August 3, 1984

HOPE CREEK GENERATING STATION  
DOCKET NO. 50-354  
DRAFT SAFETY EVALUATION REPORT  
OPEN ITEM STATUS

In addition, enclosed for your review and approval (see Attachment 4) are the resolutions to the Draft SER open items, FSAR question responses and structural geotechnical audit item responses, listed in Attachment 3.

FIGURE A-13-23  
RESPONSE SPECTRA COMPARISON,  
... .. AT ELEV 54' - 0"

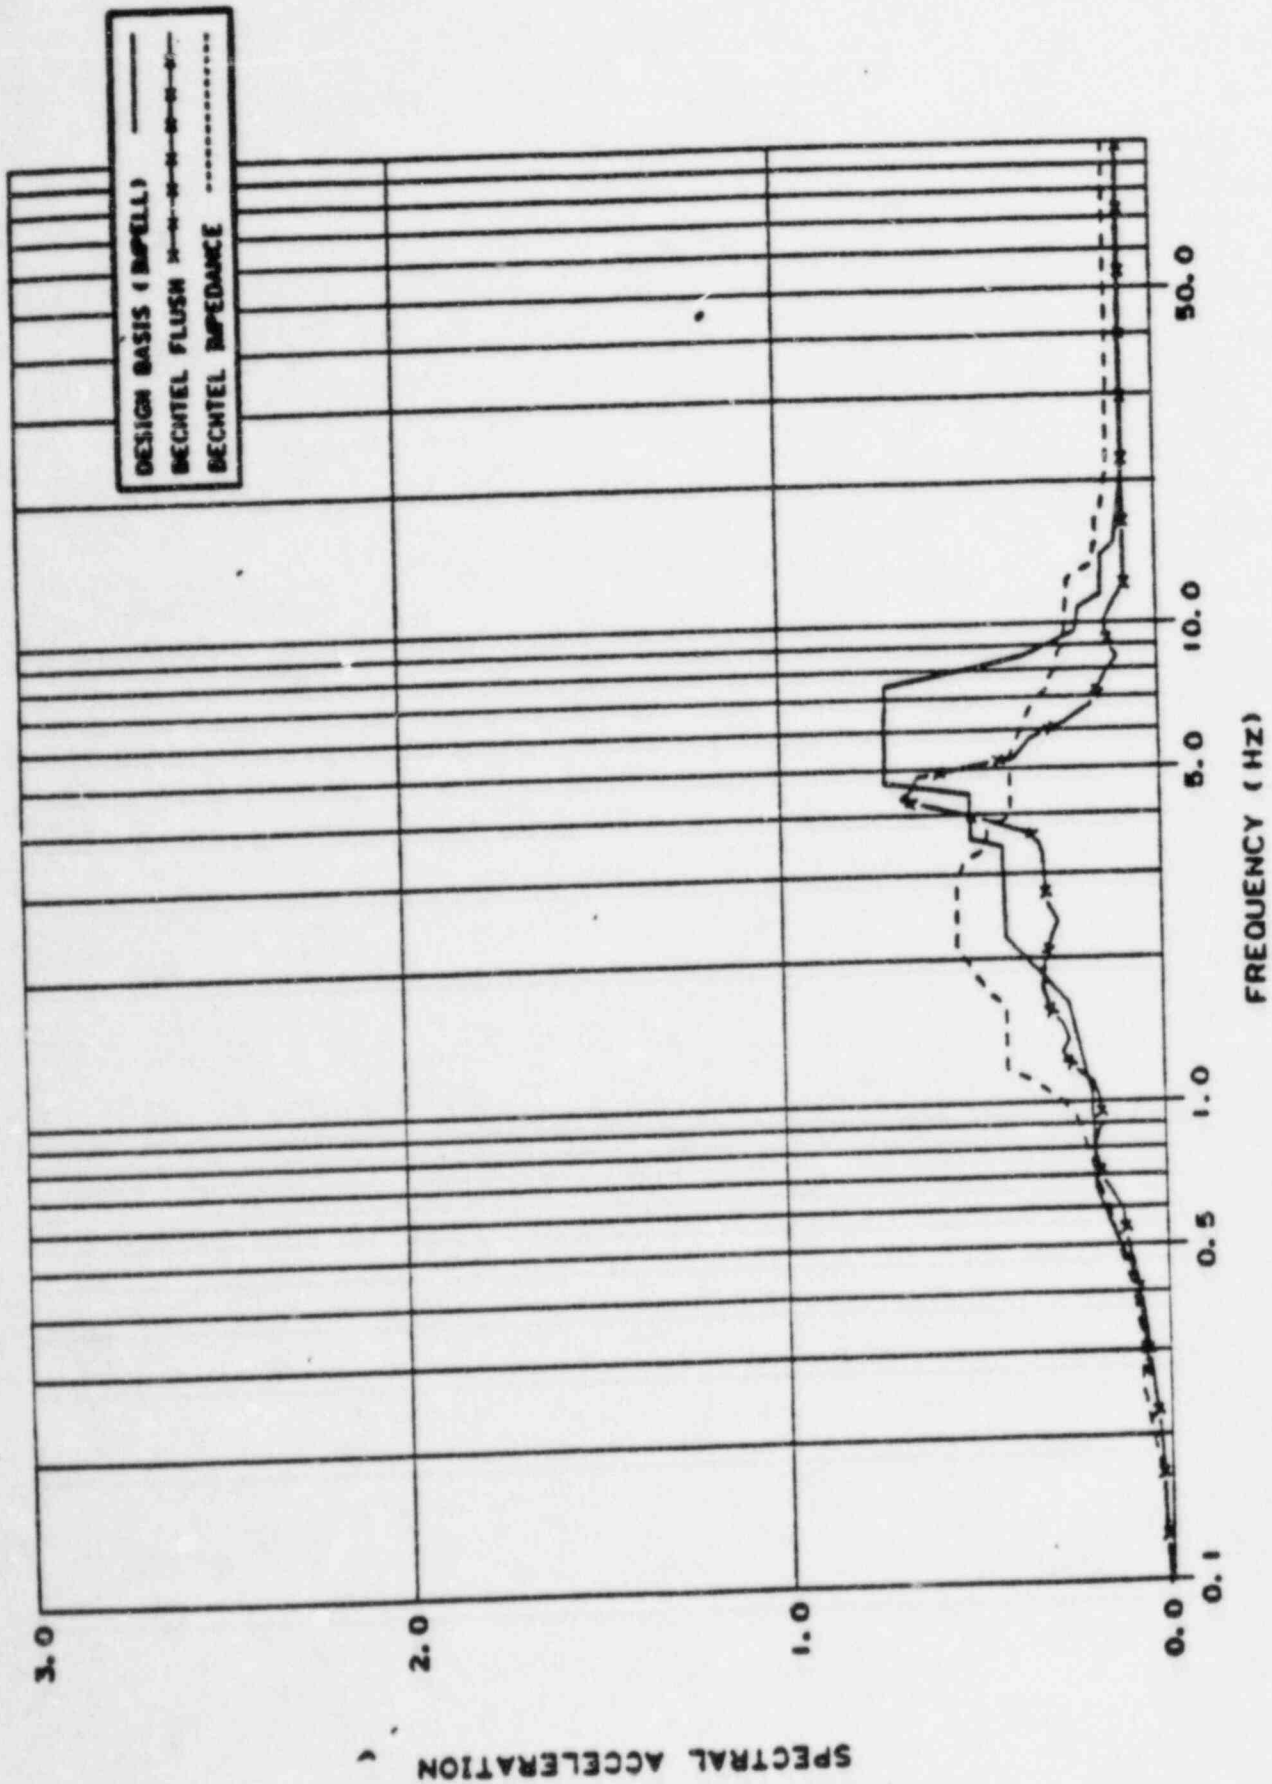
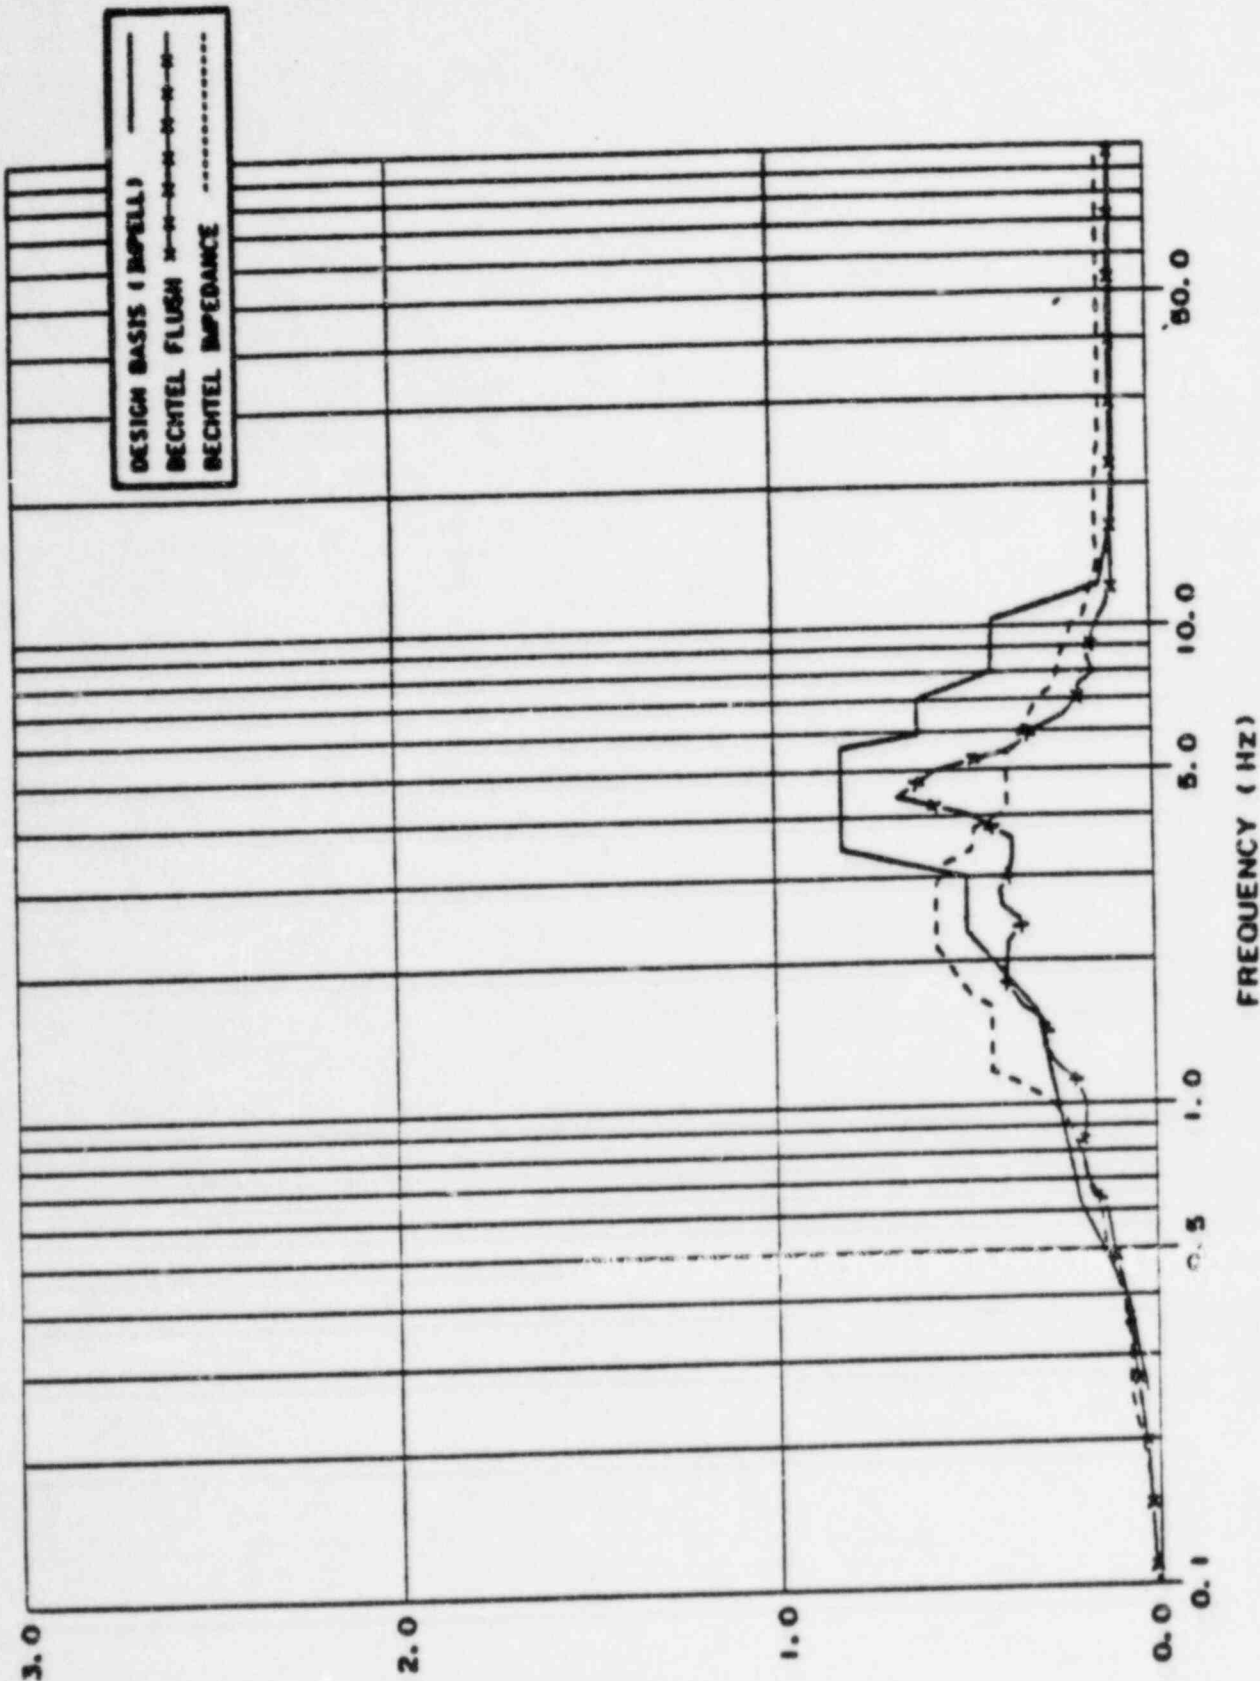
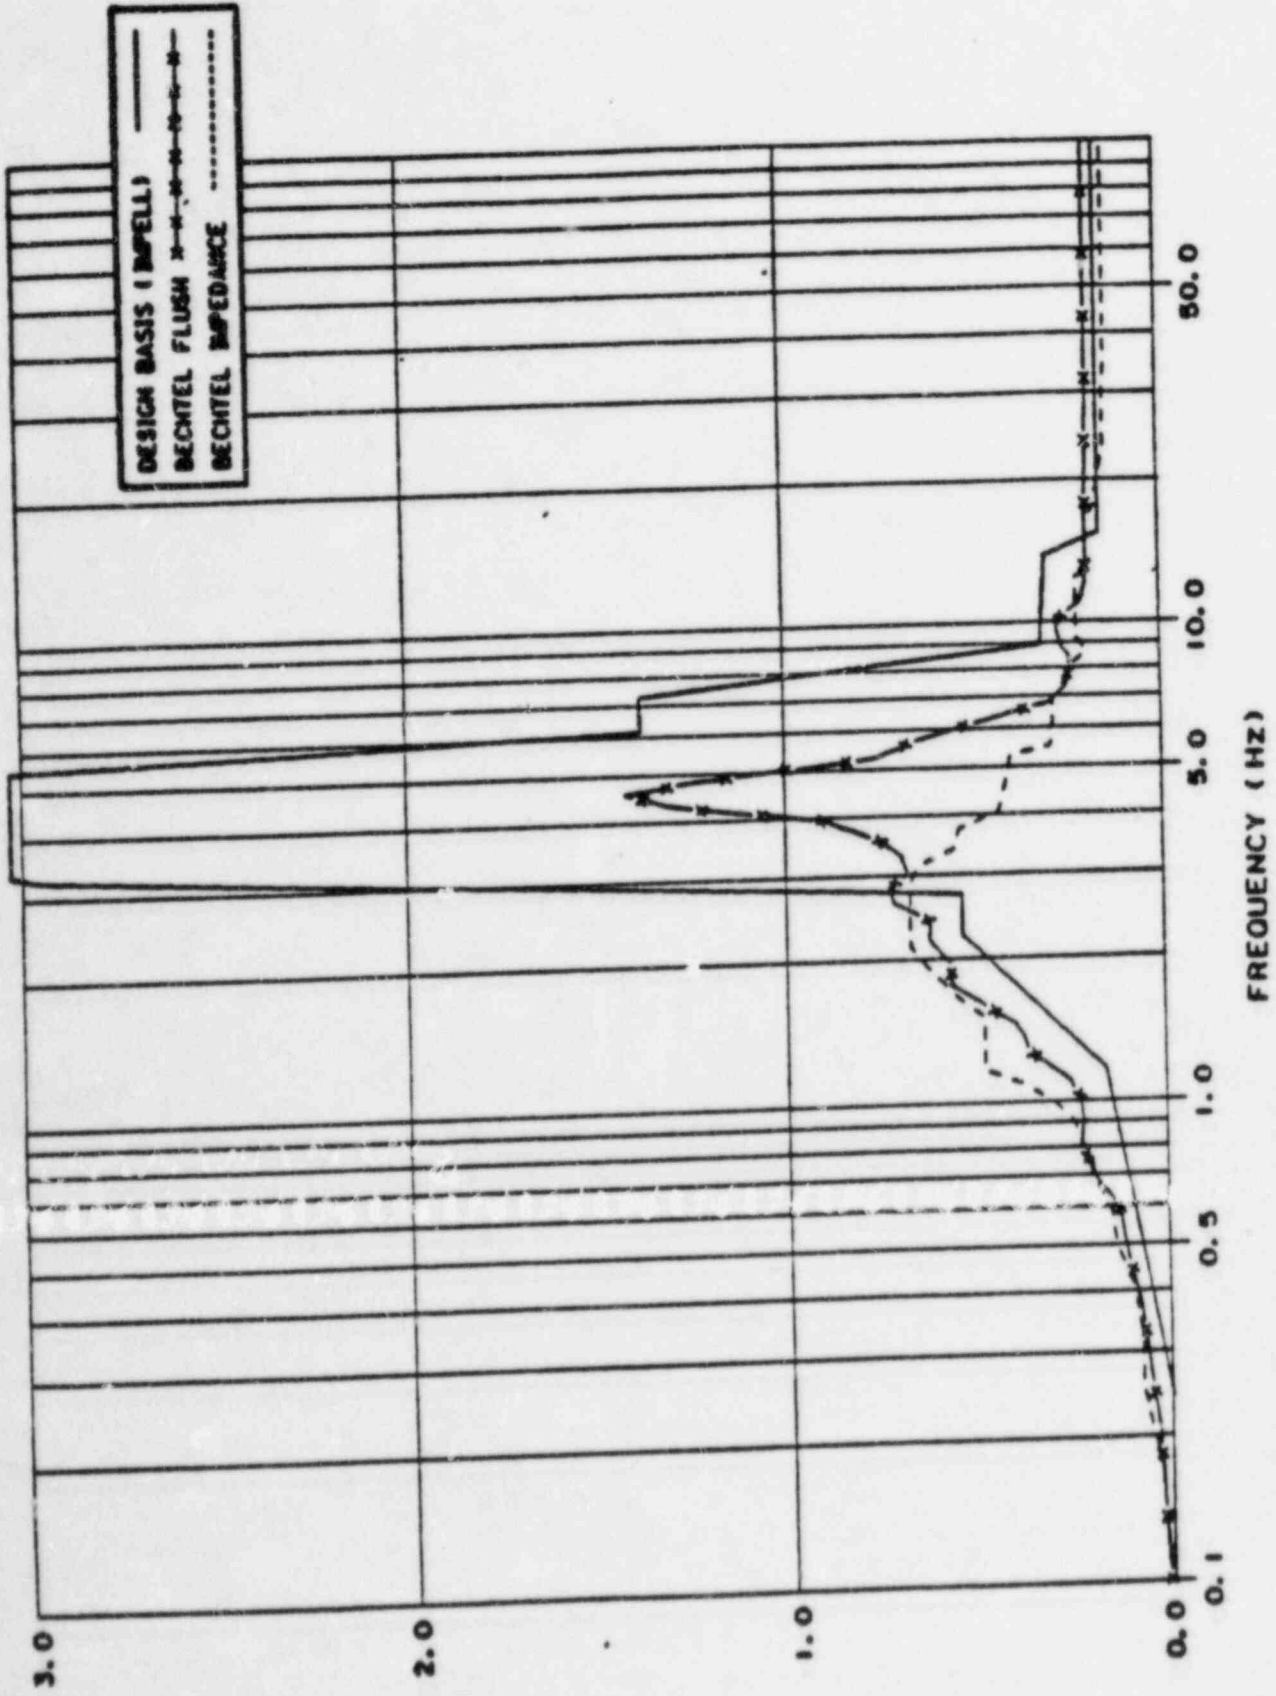
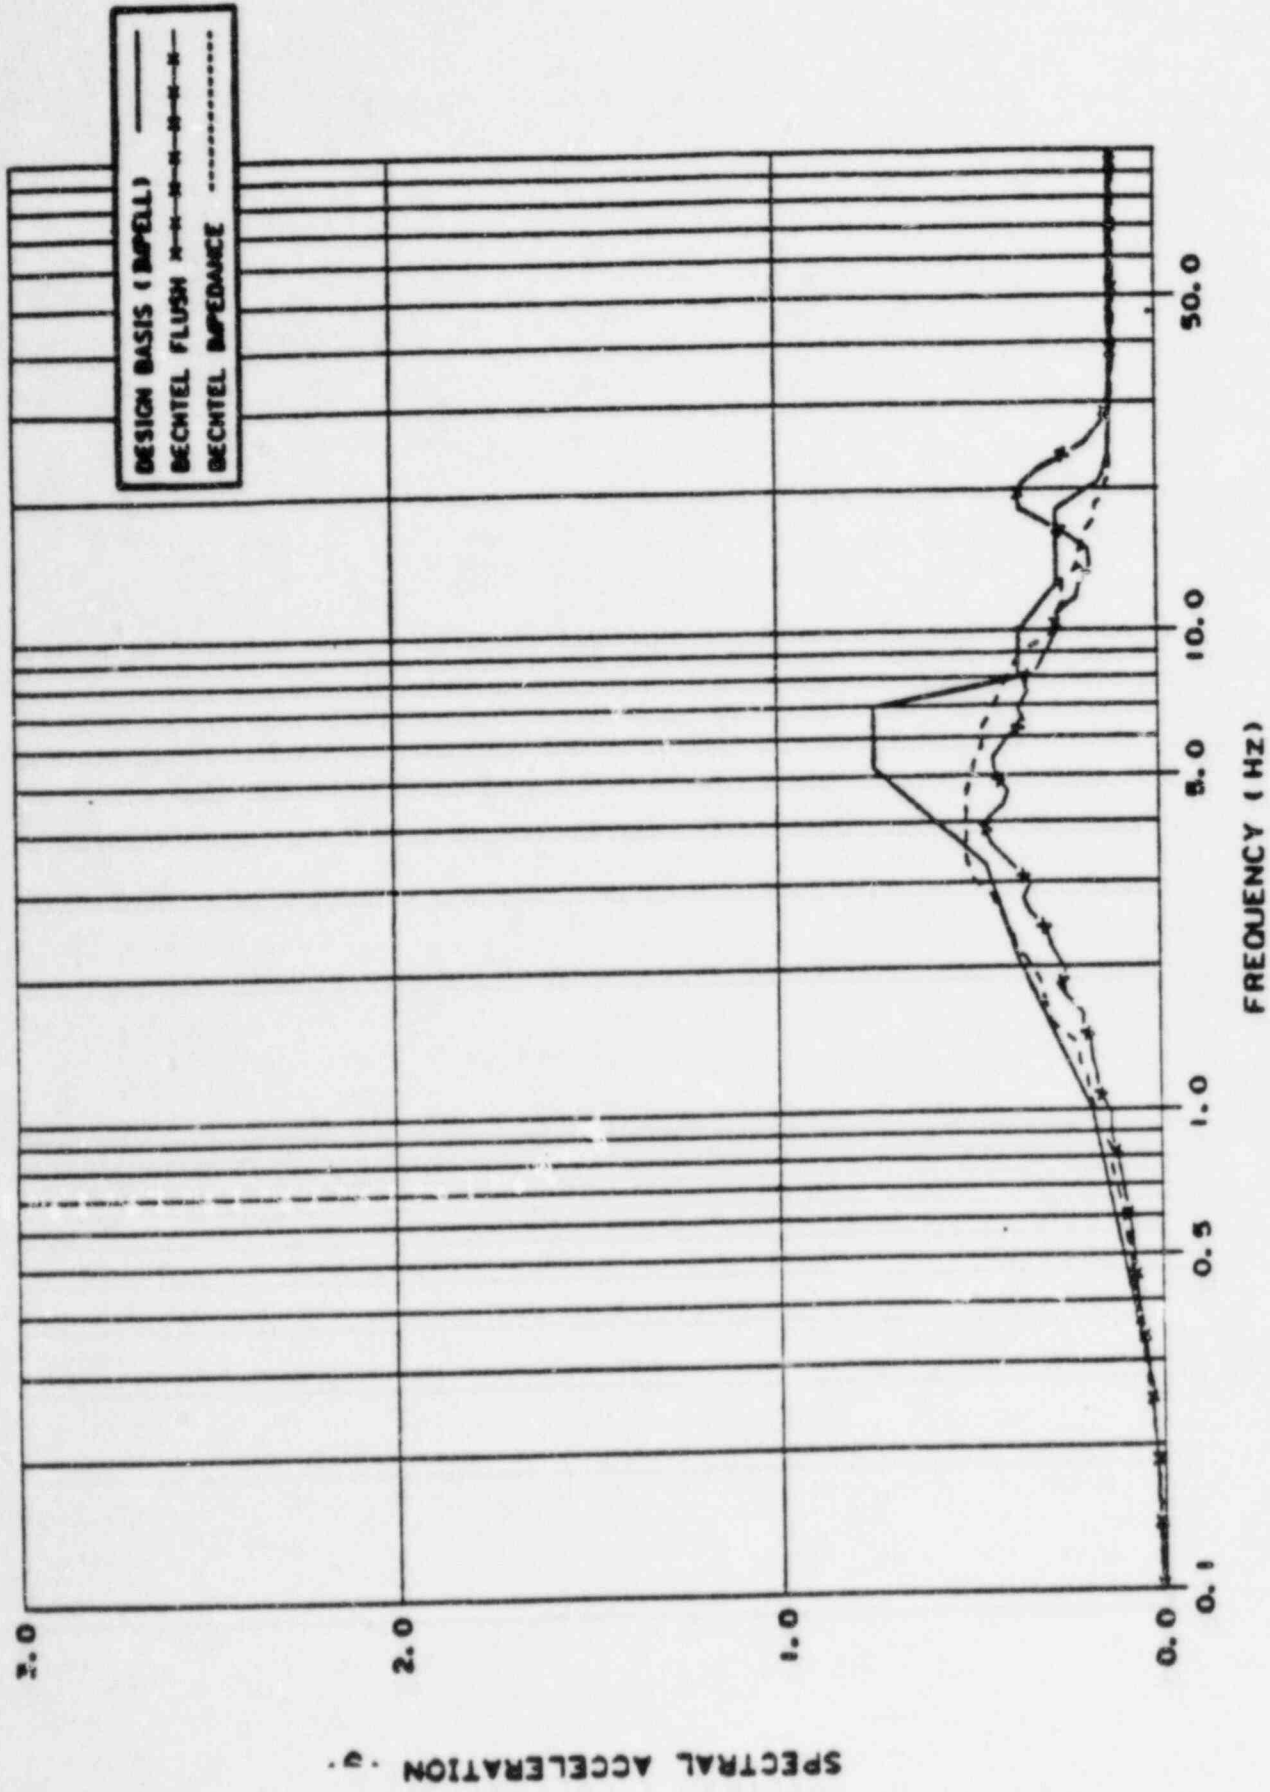
Question: Provide comparison of Bechtel Independent Verification Results with the Design Basis Results.

Figures A-13-2 to A-13-37 show the comparison of the response spectra (2% damping) obtained from the above three seismic soil-structure interaction analyses. Discussions of these comparisons are as follows:

Bechtel's independent soil-structure interaction analyses are performed using the computer code FLUSH. The results of independent finite element analyses are in reasonable agreement with those of the design basis analyses. As can be seen from Figures A-13-2 through A-13-37, the horizontal response spectra obtained from the independent finite element analyses are generally enveloped by those obtained from the design basis analyses except for the frequency range lower than 2 Hz. The vertical response spectra showed some exceedances at the frequency range of 18 Hz. These exceedances are listed in Table A-13-1.

The peak spectral accelerations obtained from the impedance approach analyses are generally lower than those obtained from the design basis analyses. However, these response spectra are not completely enveloped by those obtained from the design basis analysis, especially in the frequency range between 1.0 and 3.5 Hz. Also, there are some local exceedances in the higher frequency range, as shown in Figures A-13-2 through A-13-37.
